ROAD & PEDESTRIAN SAFETY IMPROVEMENTS ON GUILDFORD WAY AND DAVID AVE

No.	Date	By	Revisions
1	02-04-2026	BG	ADDENDUM #1 SOUTH CORNER POLE AND JB SHIFT
	05-03-2026	BG	ISSUED FOR TENDER
	21-01-2026	BG	DETAILED SUBMISSION
	28-04-2025	BP	PRELIMINARY SUBMISSION

Project: **GUILDFORD WAY FALCON DRIVE TRAFFIC SIGNAL MODIFICATIONS**
Description: _____
File: 8358-24
COQ. ASBULT No. **EXXXX**

Project: **GUILDFORD WAY LANSDOWNE DRIVE TRAFFIC SIGNAL MODIFICATIONS**
Description:
File: 8358-24

Project: **GUILDFORD WAY LANSDOWNE DRIVE TRAFFIC SIGNAL MODIFICATIONS**
 Description:
 File: 8358-24

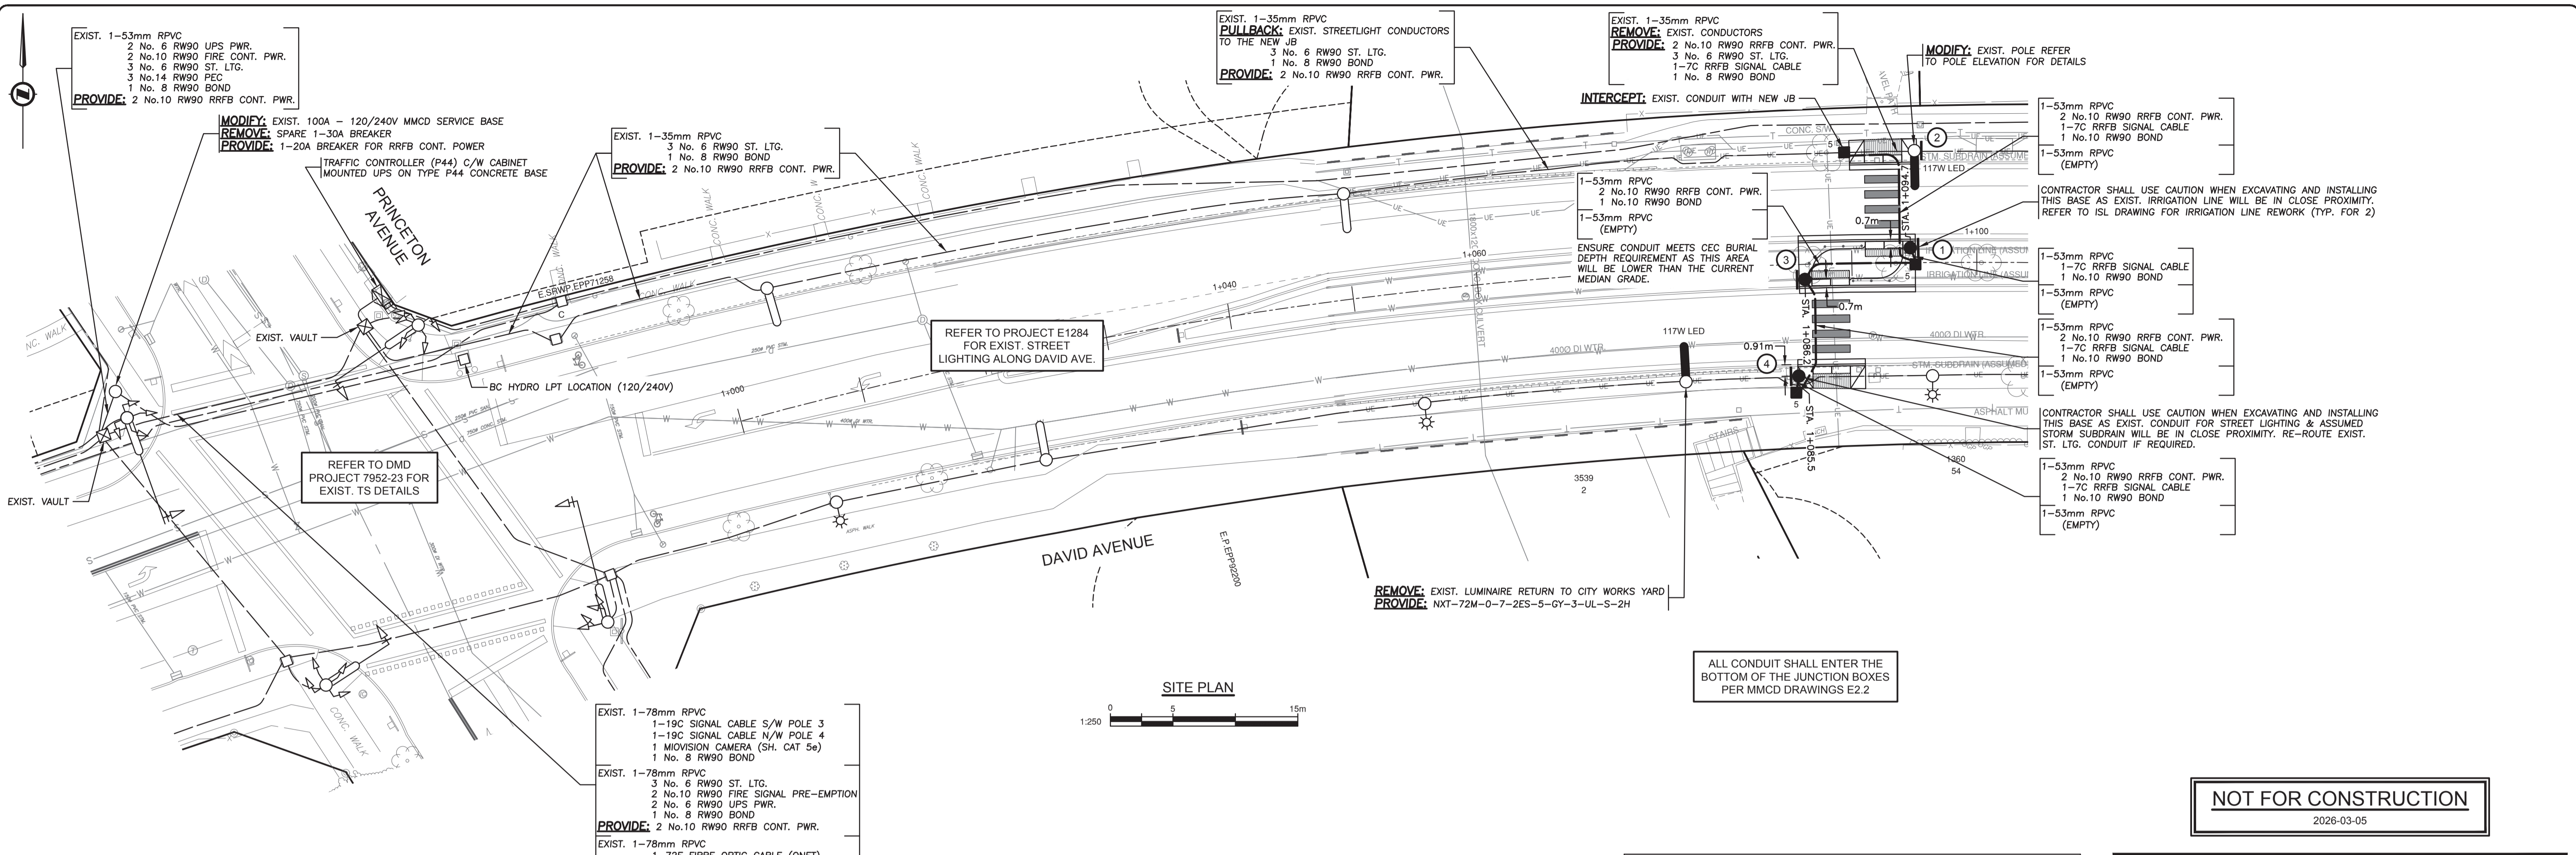
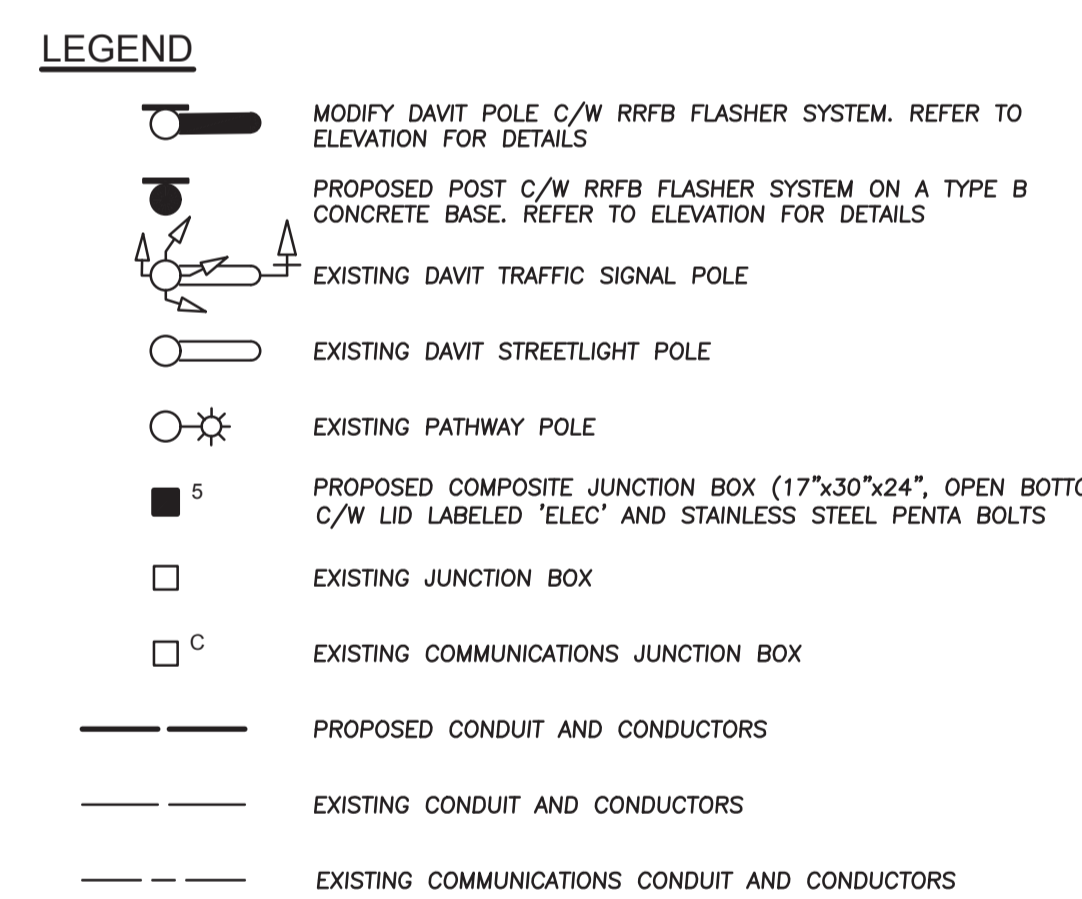
No.	Date	By	Revisions
1	02-04-2026	BG	ADDENDUM #1 - POLE 2 LOCATION AND POLE TYPE CHANGE
	05-03-2026	BG	ISSUED FOR TENDER
	21-01-2026	BG	DETAILED SUBMISSION
